# ENG-CDR21013-R3-FDR.pdf Markup Summary

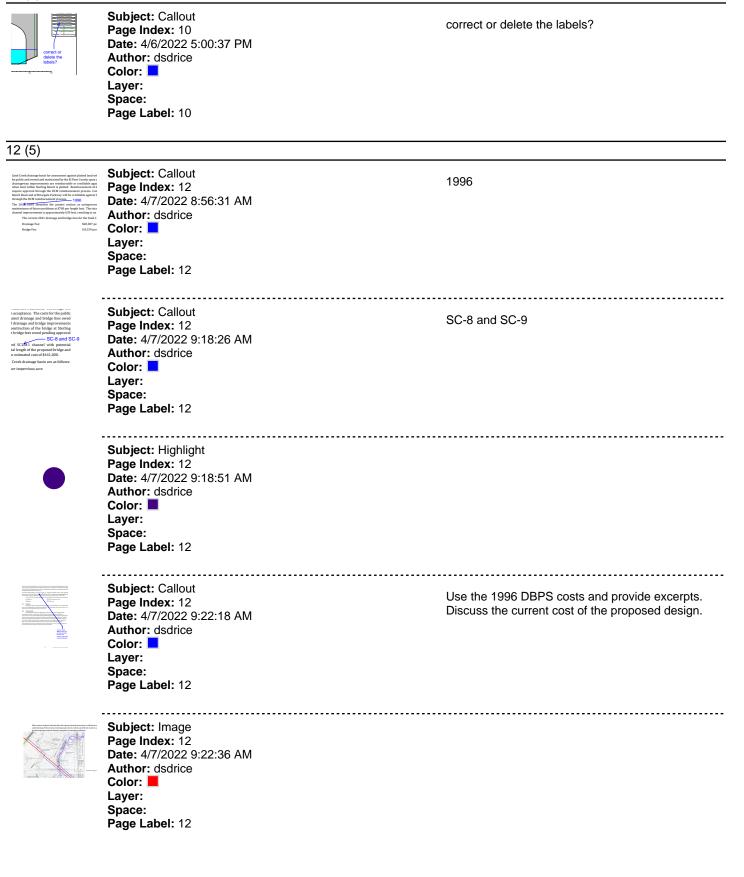
he grading plan. Appendix ear floodplain. The location EC-RAS model cross-section 0-. 50- 10<mark>0-yar and</mark> 500-yeaı p apron is included on th

yar a
